Office of Highway Safety

Road Safety Audit Review

Town:	St Albans Town	Date Reviewed:	September 7 2016
Route:	VT 36 and Georgia Shore Rd (Min 0764) Intersection	Mile points:	VT 36 MM 0.75 - 0.8 Georgia Shore MM 1.3

Implement an All-Way Stop

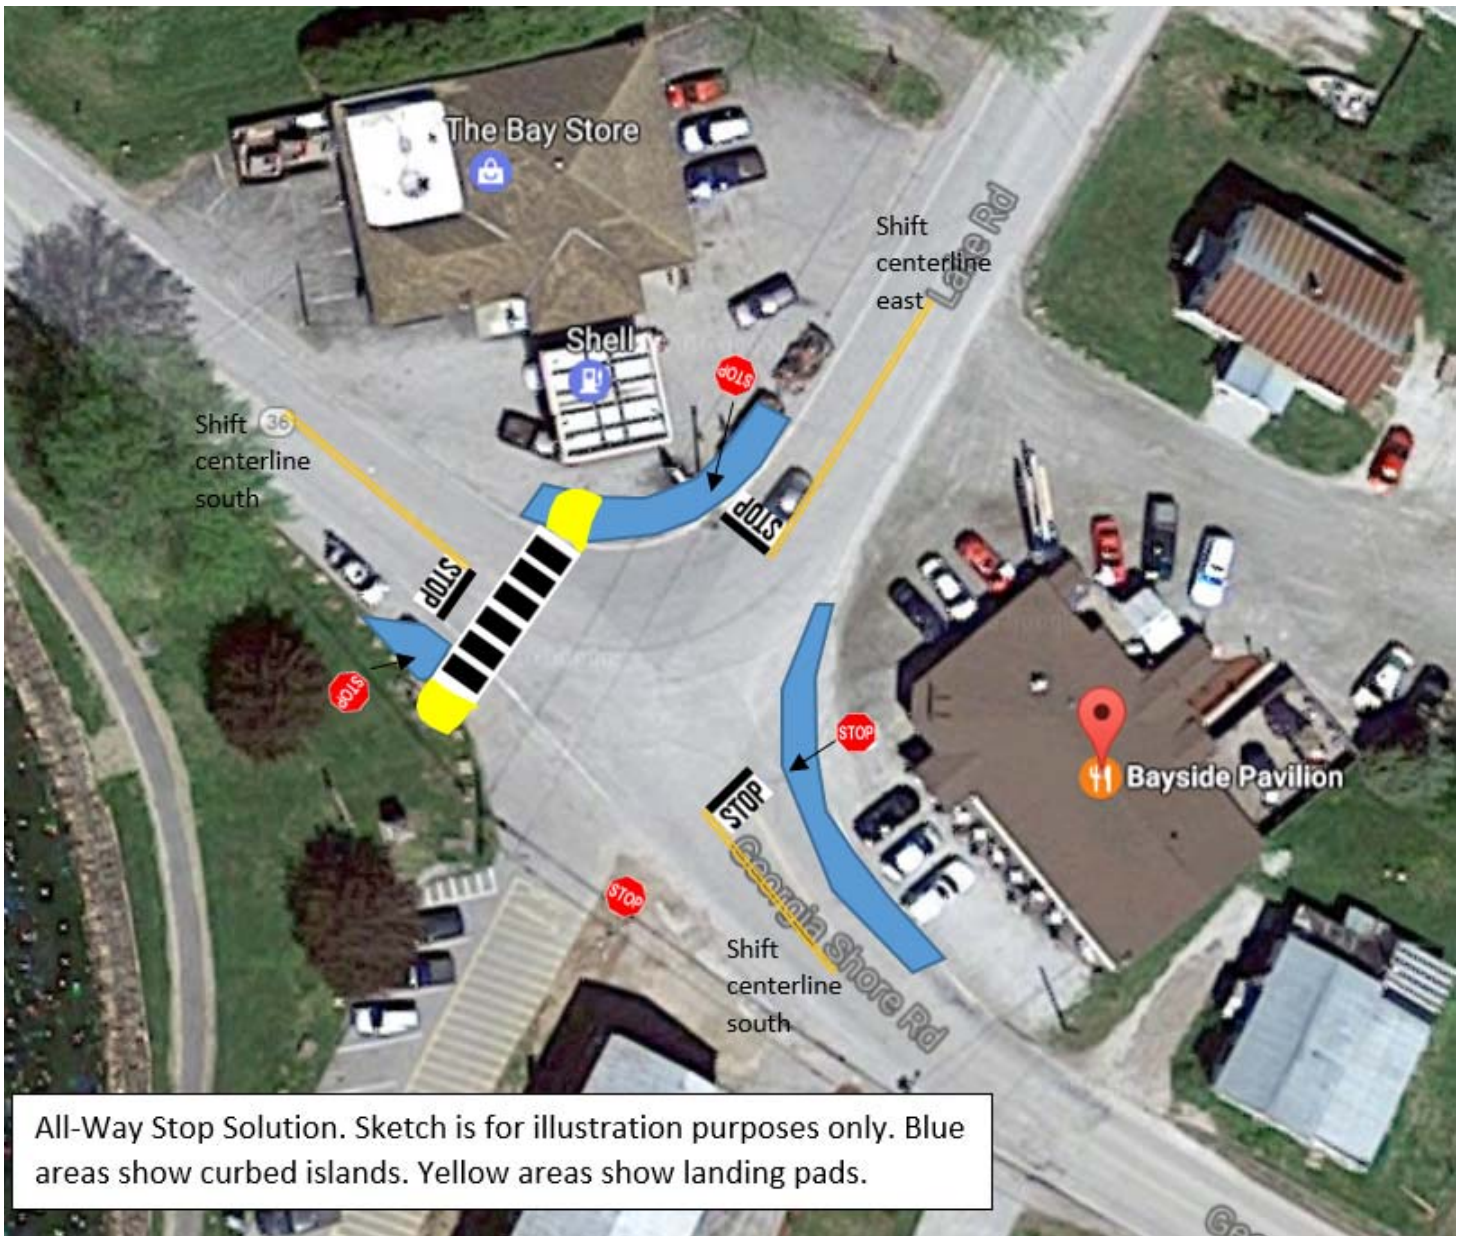
This option consists of installing new stop signs on the two VT 36 approaches to make this a three-way intersection. Access control is required to implement this option¹. Each stop sign must be installed inside an island.

To accomplish this, shifting the centerlines and providing access control as follows are suggested:

1. On Georgia Shore Road, move the centerline to the south to better align the approach, control access by the Bay Pavilion by curbing with a green strip.
2. On the VT 36 west approach, move the centerline away from the store.
3. On the VT 36 east approach (north side of the intersection), move the centerline to the left and control the access to the store by curbing.

Implement a Mini-Roundabout

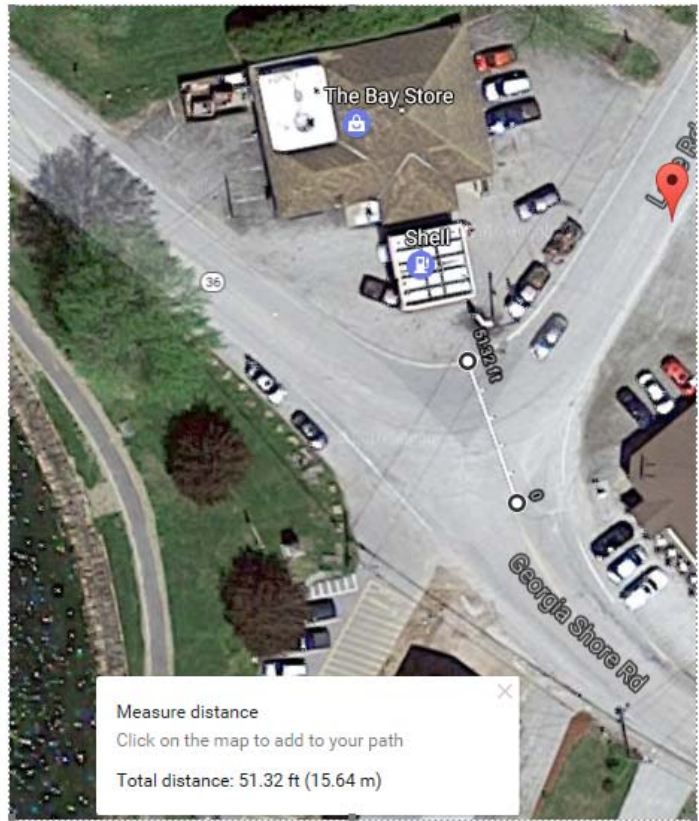
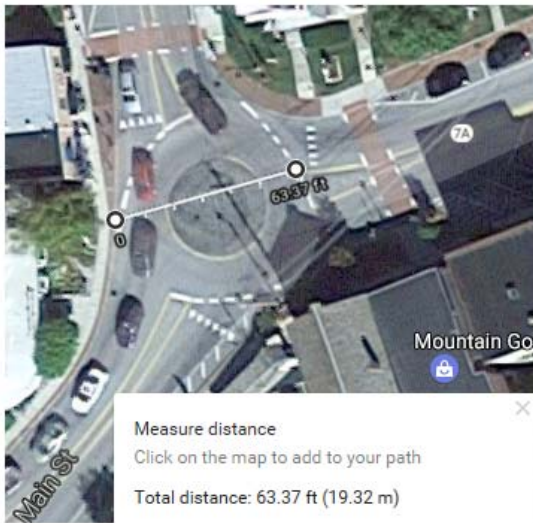
At priory, this site is suitable for the installation of a mini-roundabout. Mini-roundabouts have a small inscribed diameter (50 to 80 ft), and a small circular central island (16 to 45 ft diameter). A key feature of mini-roundabouts is that the central island is traversable, which facilitates movements by trucks (further investigation is required to ensure that trucks can navigate the location). The advantages of a mini-roundabout over all-way stop control are the greater capacity and better traffic flow. The disadvantage of a mini-roundabout over all-way stop control is district winter maintenance with current staff and equipment.

There is a mini-roundabout in Manchester. Below are a picture of this mini-roundabout and another one that shows a side-by-side comparison between the Manchester intersection and the VT 36 intersection.

The mini-round about near the Bay Store would be slightly smaller than the one in Manchester but within the typical range of dimensions. The implementation cost for such a treatment would be between \$25,000 and \$50,000 (FHWA figures). The aim would be for this mini-roundabout to be all constructed within the existing right-of-way and intersection footprint.

Access controlled at the Bay Store and at the Bay Pavilion Restaurant would also be part of this alternative. At the Bay Store, access control would be on the west side of VT36 east, while at the Bay Pavilion Restaurant, it would be a modification of what was described previously (modified to fit the mini-roundabout design).

This option also includes relocating the gas sign out of the right-of-way as mentioned in group A. Note that the VT 36 crosswalk would most likely remain at its current location since crosswalks at mini-roundabouts are set back to eliminate conflicts with turning vehicles.
